**HUGHES
SERVICE INFORMATION
NOTICE**

NOTICE NO. N-125

**SUBJECT: STATIC SYSTEM - LINE RESTRICTOR AND DRAIN FITTING
MODIFICATION KITS (M10094 AND M10094-3)**

MODELS AFFECTED: 269C Helicopters Serial No. 0001 through 0389

Figure 1. Static system - line restrictor and drainage fitting modification kits (M10094 and M10094-3)

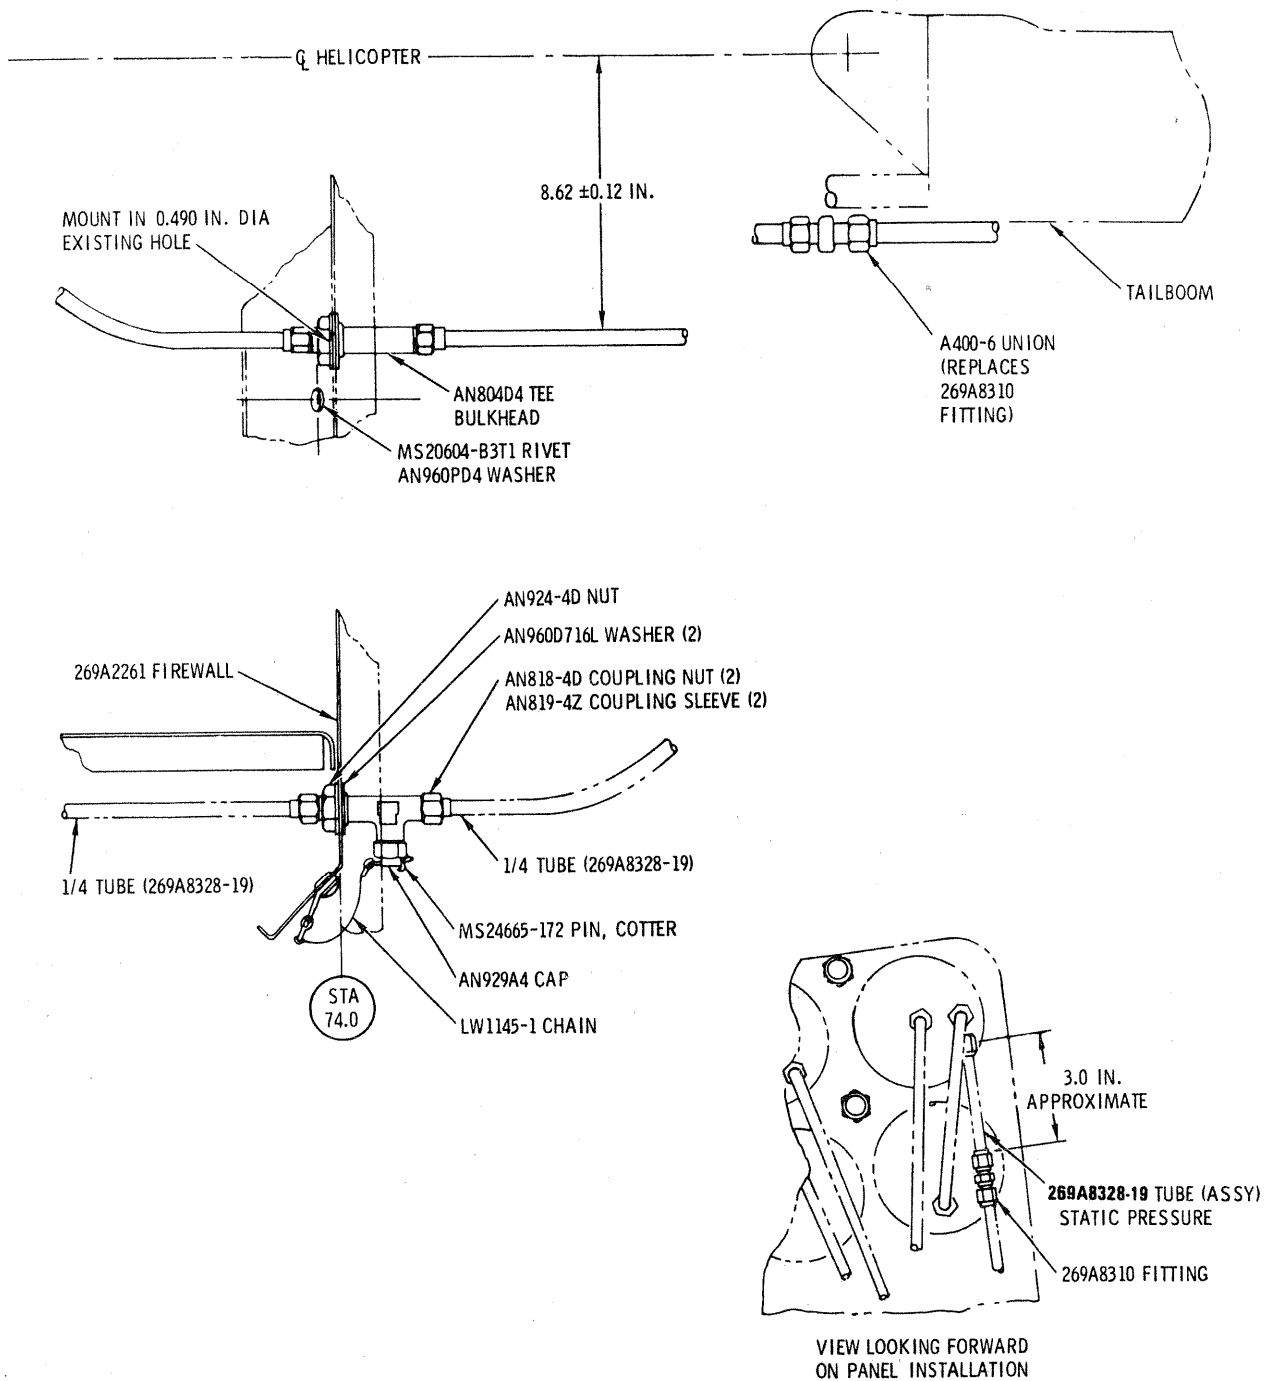
PREFACE: Part I of this Service Information Notice lists a procedure for (1) optional relocation of the static line restrictor fitting to a new position near the airspeed indicator, thus reducing the possibility of moisture entering the restrictor passage and plugging the static system, and (2) installation of a new drain fitting to provide a sump area and facilitate drainage of the static system when necessary.

d. Remove 269A8310 restrictor fitting from static tube at forward end of tailboom; remove tie-straps securing static tube to helicopter center frame.

e. Remove existing plug in lower LH fuselage firewall; install new bulkhead tee in 0.490-inch hole. (See Figure 1.)

f. Install chain (with cotter pin attached) to firewall adjacent to and below tee, using rivet and washer as shown. Use #40 drill; install rivet with zinc chromate primer.

g. Install existing 269A8310 restrictor fitting by inserting the fitting into the 269A8328-19 static tube at new location behind instrument panel as shown. Rework length of -19 static tube as required .

h. Connect -19 static tube to forward port of bulkhead tee, using hardware as shown. Rework length of -19 static tube as required.

j. Install -19 static tube to union and to aft port of bulkhead tee, using hardware as shown. Rework length of -19 static tube as required.

Lowest part of static tube must be at connection to tee to allow for proper drainage.

- a. Check that all electric and power is OFF; pay particular attention to MAG switch.
- b. Remove instrument panel fairing.
- c. Remove existing 269A8310 restrictor fitting from static tube at forward end of tailboom; replace with new A400-6 union as shown. (See Figure 1.)
- d. Install 269A8310 restrictor fitting to 269A8328-19 static tubes at new location at instrument panel as shown. Rework length of static tubes as required.
- e. Check installation of restrictor fitting and union for discrepancies.
- f. Install instrument panel fairing.
- g. Perform flight test to check operation of altimeter and airspeed indicator.
- h. Record relocation of 269A8310 restrictor fitting (Modification Kit No. M10094-3) in Compliance Record of helicopter Log Book.
